**In the drawings:**

## **REMARKS**

FIG. 3

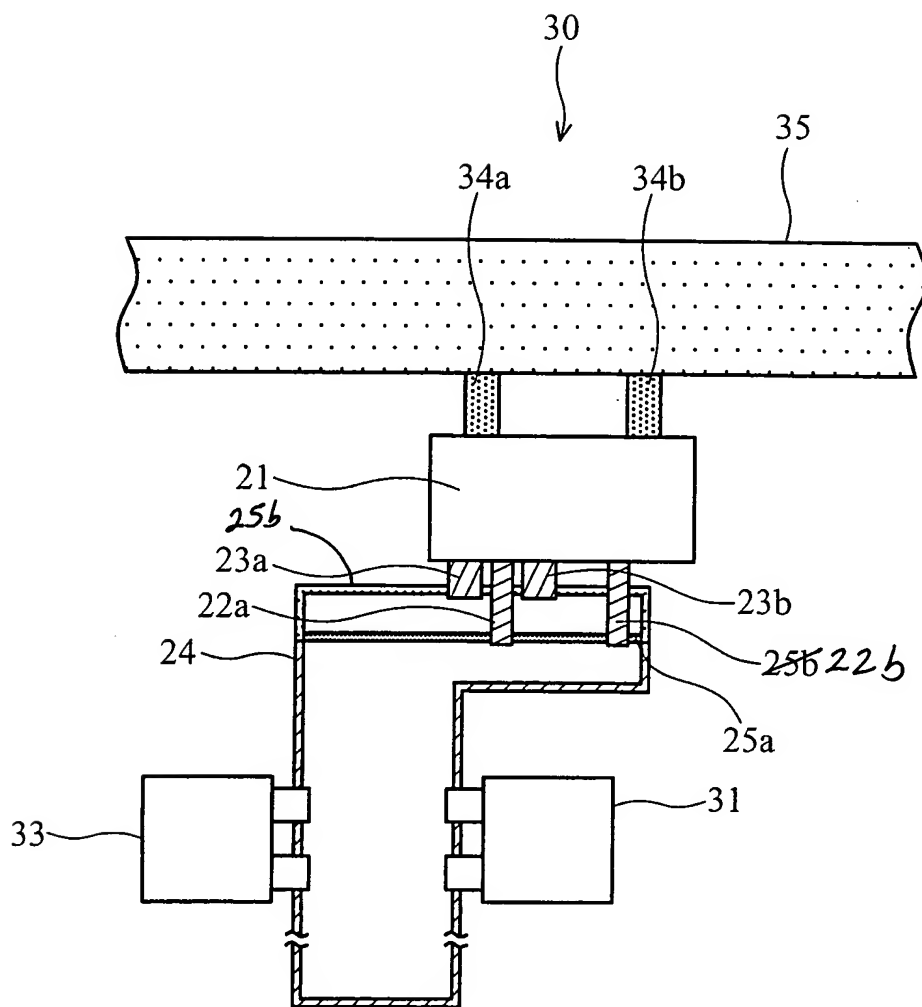
In FIG. 3, reference number 25b has been changed to 22b and a new reference number 25b has been added, as shown in the accompanying drawing sheets (both annotated drawing sheet and replacement drawing sheet).
